RE: Minor modification request for Elan building A1 due to surveying malfunction

1) 2nd AMENDMENT TO SIP

2) CURRENT 'AS-BUILT' FOR MINOR MODIFICATION

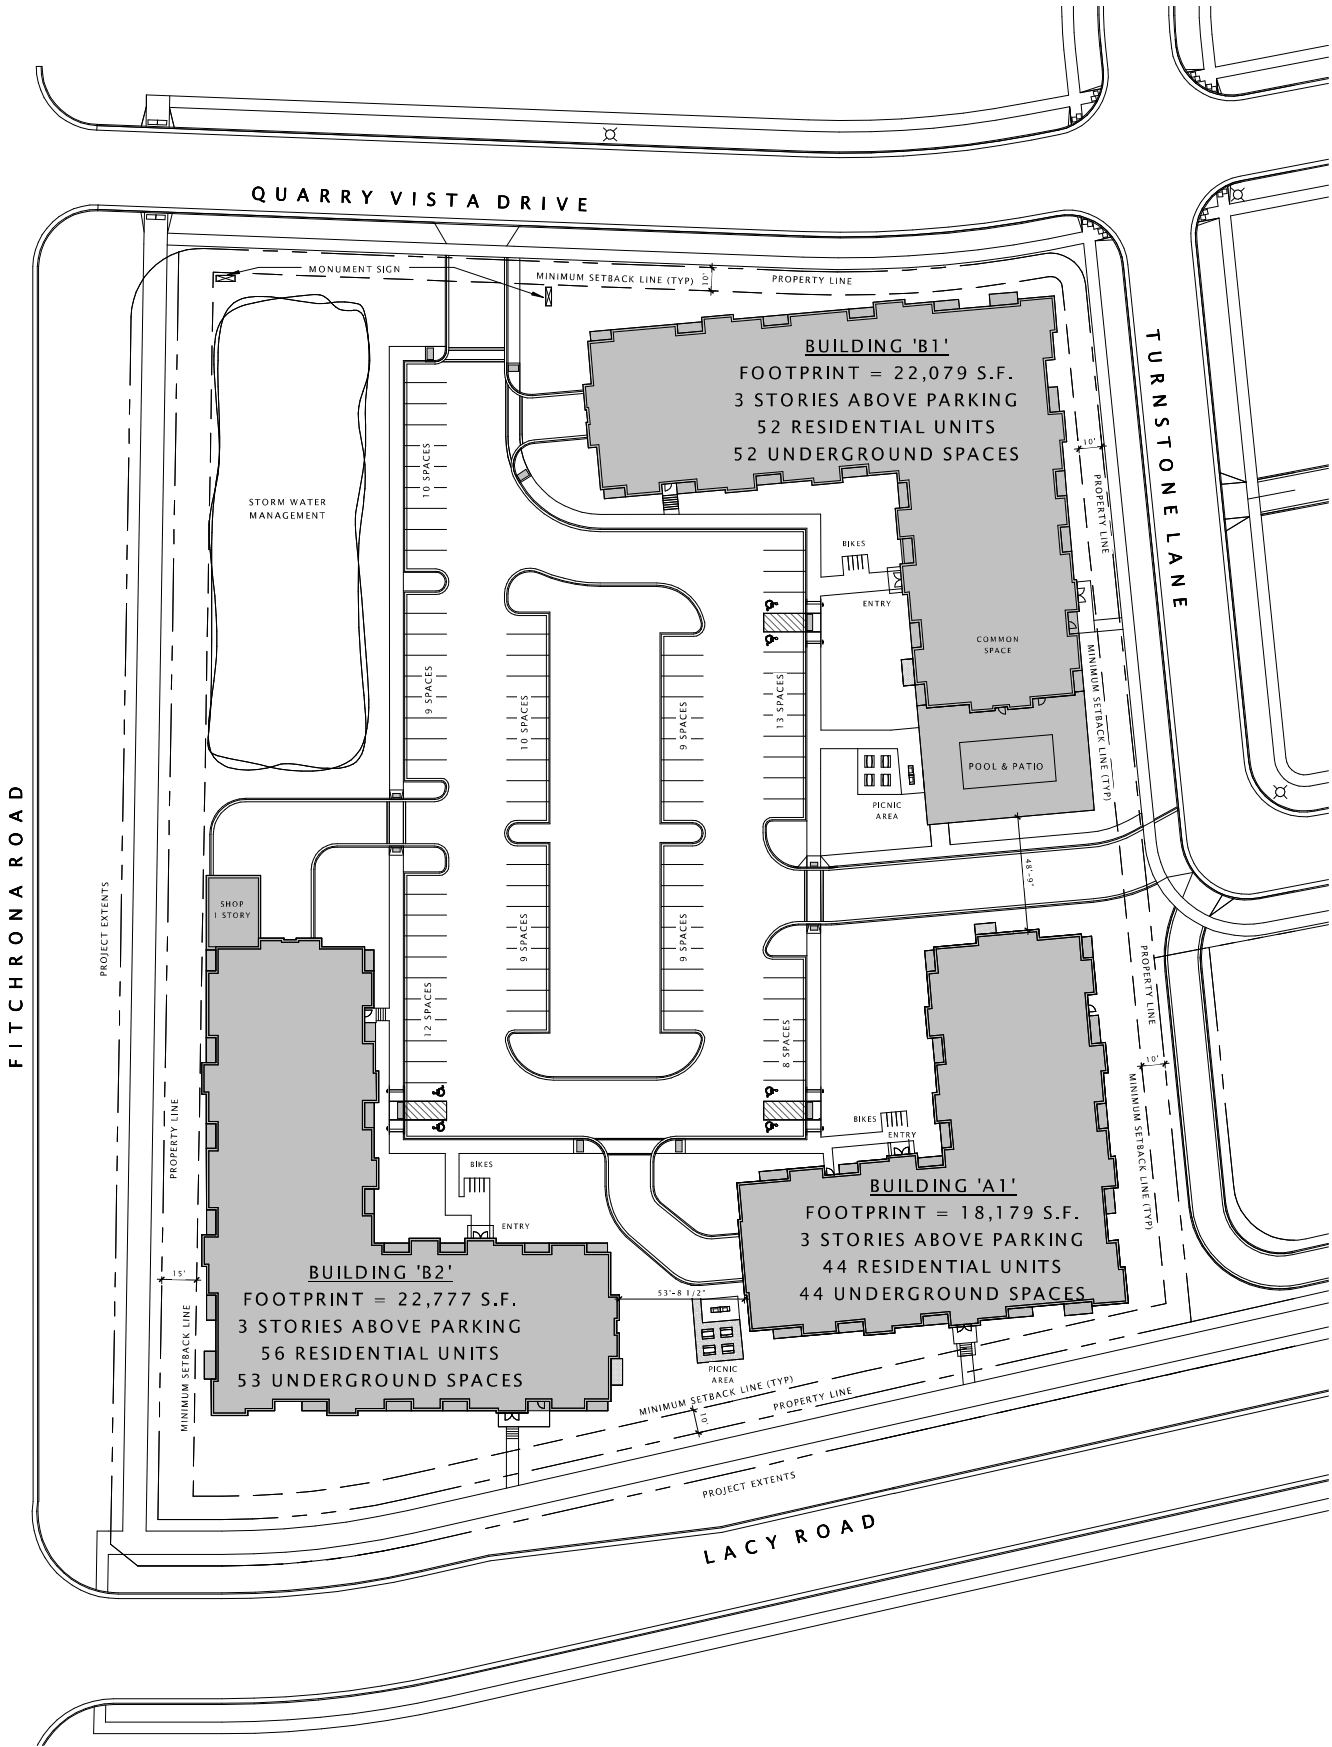
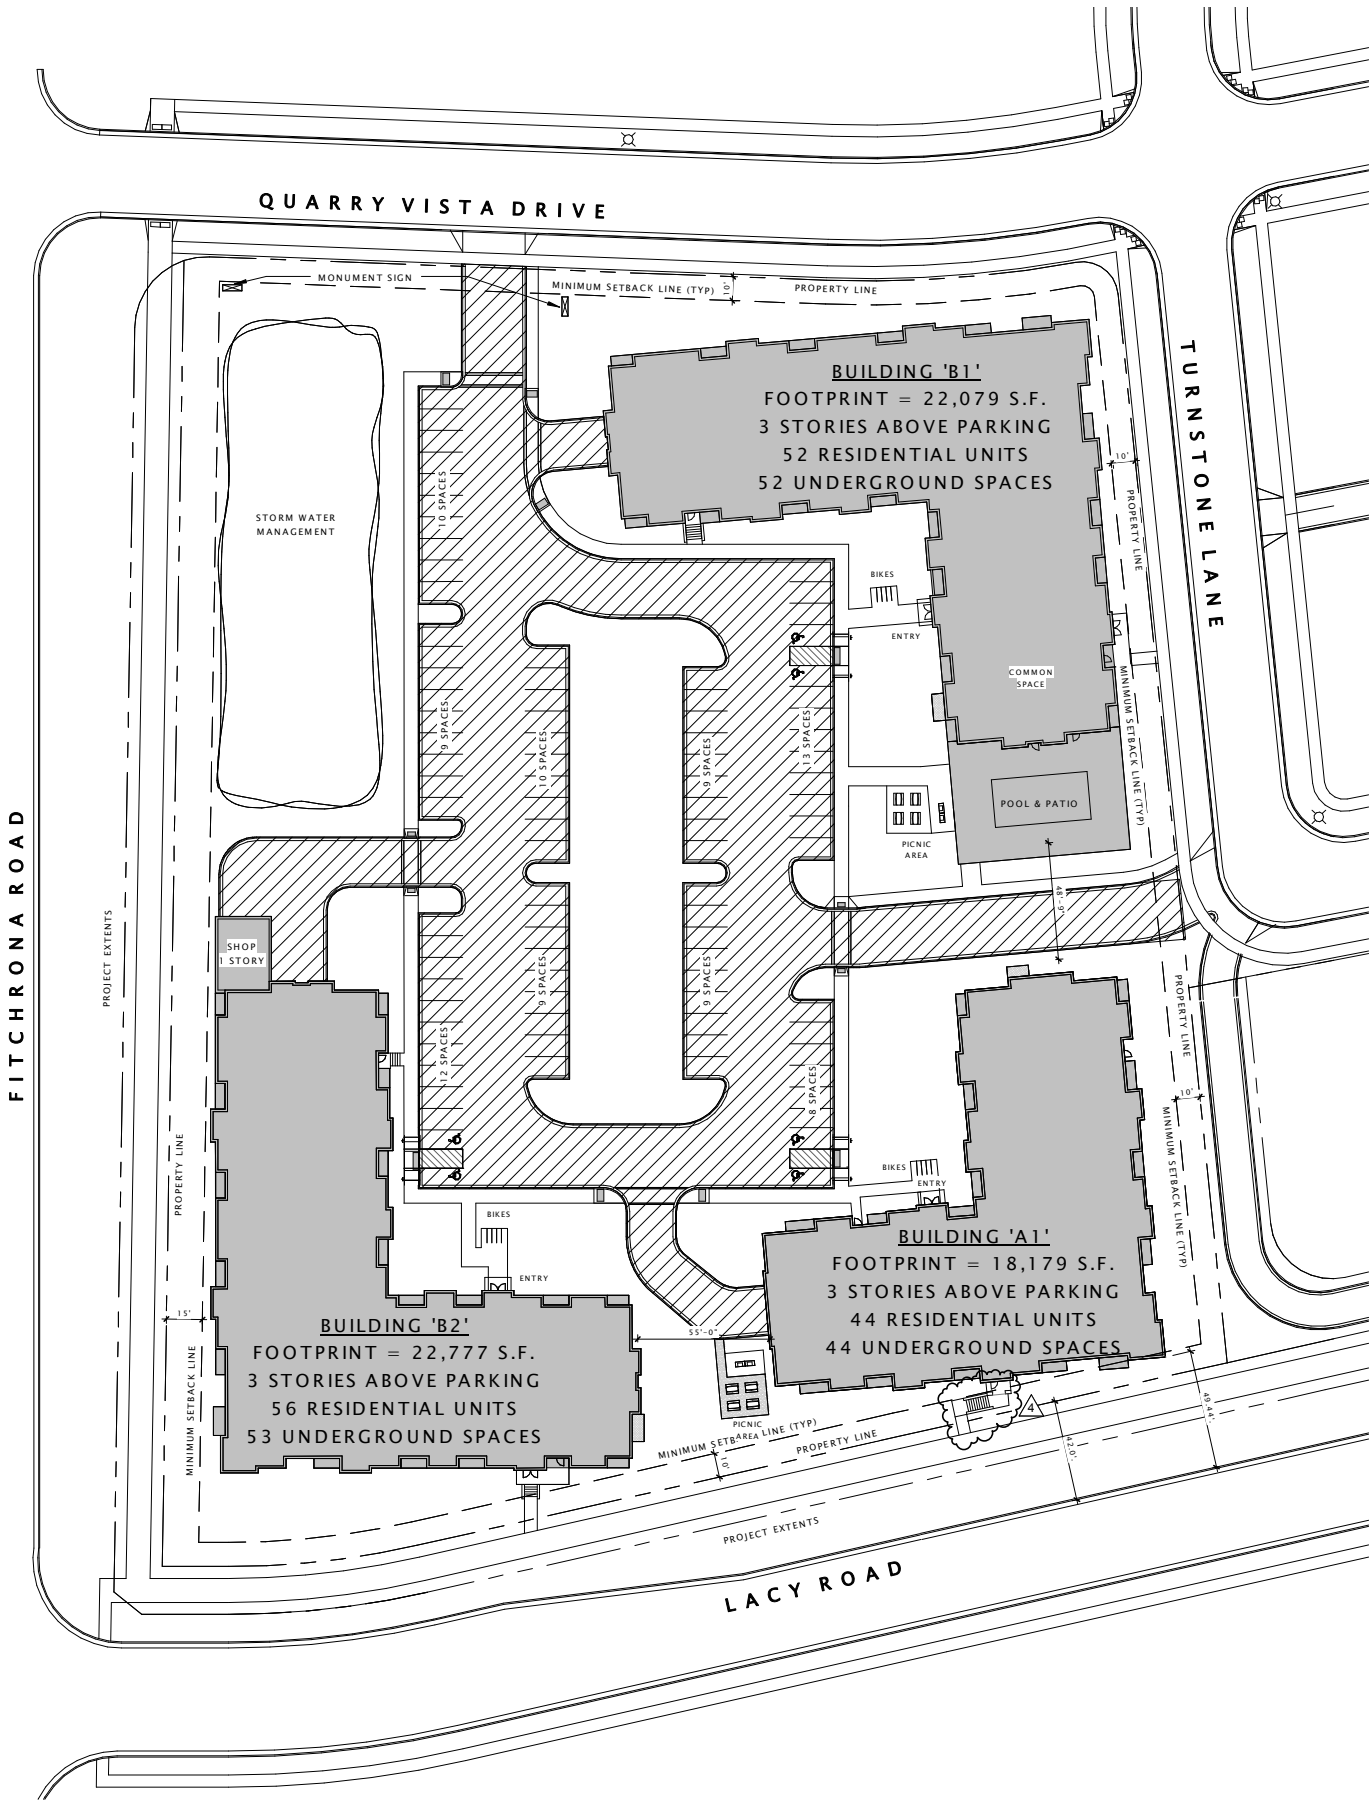
To recap, building A1's southeast corner was planned and approved to be approximately 3.5 feet back from the setback line. The surveying error was approximately 5.5 feet, and now that corner encroaches into the setback line 1.89 feet.

- Per the attached drawing (#2 – current “as built” for minor modification), there are three areas noted as encroaching into the setback – 72.65 square feet. Two of the areas are the front stoop and a unit porch, and the only “building portion” is the SE corner – 13.46 square feet.

- The stairway is not included as encroaching, but it is larger than previously shown and approved. JLA architects ran the impervious surface ratio and it increases 1/10th of 1%, now 58.3% from 58.2%. The SIP is approved for a maximum ISR of 60%

- The last, and hopefully most important reason to consider a minor modification is the surrounding area. The Fitchrona/Lacy intersection and corridor is a more rural environment. On the above attachment we have identified the distance between the building and the edge of the road varies between 50 and 58 feet. With regard to the 20 foot bike path easement, the 10 foot path is centered, leaving 5 feet to our property line. The new stairs are approximately 2.5 feet off the property line leaving 7.5 feet of greenspace between the paths edge and the stairs.
